**Evaluation of the National Energy Board's Trans Mountain  
Expansion Project Report in relation to Oil Spill Planning  
and Response**

Prepared by  
**Elise DeCola**

for  
**Tsleil-Waututh Nation**

**November 23, 2016**

**Figure 39 - Hypothetical Accident Locations – assumed oil spill locations in orange**

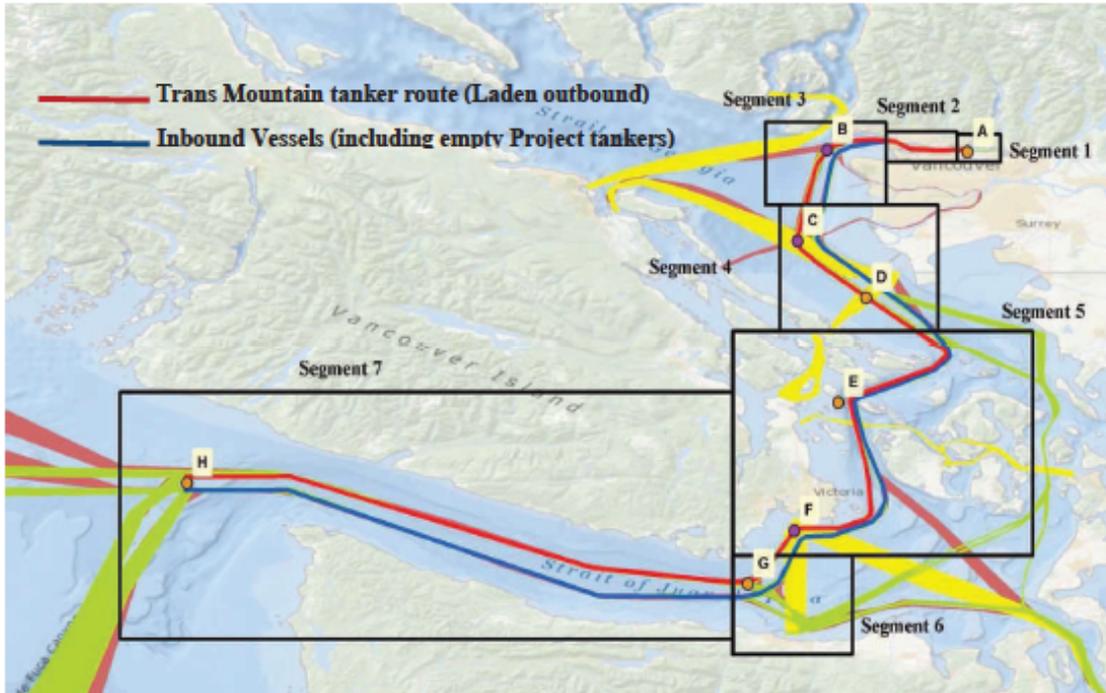
32. Trans Mountain identifies a 16,500 m<sup>3</sup> spill as the "credible worst case" discharge for tankers along the route to and from Westridge Terminal, but based on a route analysis, concludes that the probability of initiating events that could cause a spill this size is credible at locations D through H (see reprint of Figure 39 map, below), but not at locations A through C.

33. Trans Mountain's reply evidence points to this analysis in stating that Nuka Research's analysis of spill response capacity for a 16,000 m<sup>3</sup> spill in English Bay is not credible, since the initiating event is so unlikely. The NEB's May 2016 Report accepts Trans Mountain's position on the following basis:

The Board does not accept the assertion made by participants that spill volumes ranging from 8 000 m<sup>3</sup> at the Westridge Marine Terminal to 16 000 m<sup>3</sup> at other locations in Burrard Inlet are credible worst-case scenarios. The Board notes that Trans Mountain's risk assessments show a very low likelihood of major oil spills within Burrard Inlet and English Bay. No credible large oil spill scenarios in these segments of the transit were identified and this view is supported by the TERMPOL Review Committee's report. Further, in response to a question from Port Metro Vancouver, Trans Mountain filed additional evidence indicating that an incident in Burrard Inlet would not be likely to puncture a double-hulled tanker. Trans Mountain also discussed specific marine safety mitigation measures within Burrard Inlet and area such as pilotage, tug escort, and traffic restrictions. The Board accepts Trans Mountain's evidence in response to the assertion made by Tsleil-Waututh Nation, City of Vancouver and the City of Burnaby that a potential large spill for a tanker at anchor in English Bay is not credible. Among other reasons, Trans Mountain said that there is no incident on record of a vessel being struck by another while at anchor in English Bay; in the event of a collision, there would not be sufficient energy to puncture both hulls of a double hull tanker; and a laden tanker would not be likely to anchor in English Bay.

34. As with the worst case discharge for the Westridge Terminal, the NEB has opted to accept Trans Mountain's assertion that the low probability of certain types of spills occurring renders planning for their occurrence unnecessary. Other experts, such as the Concerned Registered Professional Engineers (CPE), offered analysis to support the fact that Trans Mountain has overlooked potential initiating events—i.e. a laden tanker striking the Second Narrows bridge<sup>10</sup>—that could result in much more substantial spill volumes within Burrard Inlet.
